ATS Technician's Guide

NUMBER: 1-ATS-07 **S.M. REF.:** Listed in Table 1 **ENGINE:** ATS **DATE:** April 2007

SUBJECT: CHANGES IN TROUBLESHOOTING

PUBLICATION: 7SE63

Figure 1 DPF Outlet Temperature Sensor

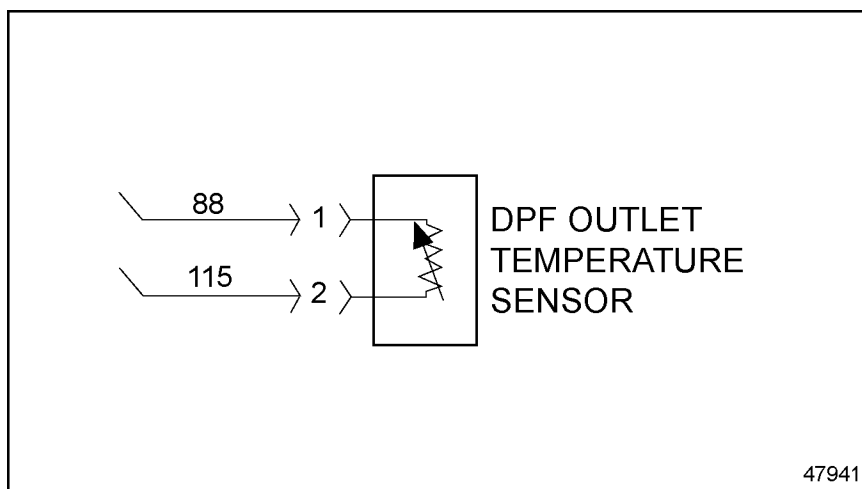
Section	Change
5.3.1, Hazardous Applications	The definitions for the two CPC options were changed to clarify their function.
7.1, SPN 51/FMI 2	FMI 2 with its troubleshooting procedure was added to SPN 51.
10.3, SPN 3246/FMI 3	The directions in step 2 of the troubleshooting procedure were changed for SPN 3246/FMI 3.
11.3, SPN 3250/FMI 3	The directions in step 2 of the troubleshooting procedure were changed for SPN 3250/FMI 3.
16.2, SPN 3556/FMI 1	The directions in step 6 of the troubleshooting procedure for SPN 3556/FMI 1 were changed.
19, SPN 3719	For SPN 3719, FMI 14 was changed to FMI 31. FMI 15 and 31 were defined as silent codes.

1. Turn ignition ON (key ON, engine OFF).
2. Check for multiple codes.
 - [a] If 3246/3, 3242/3, 3250/3, and 1172/3 are present, go to step 3.
 - [b] If only 3246/3 is present go to step 5.
3. Disconnect the Turbo Compressor Inlet Temperature sensor.
4. Measure the voltage between pin 1 of the Turbo Compressor Inlet Temperature and ground (battery ground lug by starter).
 - [a] If the voltage is greater than 2.75 volts, repair the short to power between pin 88 of the 120-pin MCM connector and the Turbo Compressor Inlet, DOC Inlet, DOC Outlet, and DPF Outlet temp sensors. Verify repairs.
 - [b] If no voltage is present on pin 1 of the intake air sensor, repair the open between pin 88 of the 120-pin MCM connector and the Turbo Compressor Inlet, DOC Inlet, DOC Outlet, and DPF Outlet temp sensors. Verify repairs.
5. Disconnect the DPF Outlet Temperature Sensor. See Figure 1.

6. Check resistance between pin 1 and pin 2 of the DPF Outlet Temperature Sensor. Listed in Table 2 are the acceptable resistances.

- [a] If resistance is out of range, replace the DPF Outlet Temperature Sensor.
 - [b] If resistance is within range, go to step 7.
7. Turn ignition ON (key ON, engine OFF).
8. Measure voltage between pin 1 and pin 2 of the DPF Outlet Temperature Sensor connector.
- [a] If the voltage is between 2.75 and 3.25 volts, verify repairs.
 - [b] If the voltage is less than 2.75 volts, go to step 9.
9. Measure voltage between pin 2 of DPF Outlet Temperature Sensor connector and ground (battery ground lug by starter).
- [a] If the voltage is between 2.75 and 3.25 volts, then repair open in wire between pin 88 of the 120-pin MCM connector and pin 1 of the DPF Outlet Temperature Sensor connector. Verify repairs.
 - [b] If the voltage is less 2.75 volts, then repair open in wire between pin 2 of the DPF Outlet Temperature Sensor connector and pin 89 of the 120-pin MCM connector. Verify repairs.
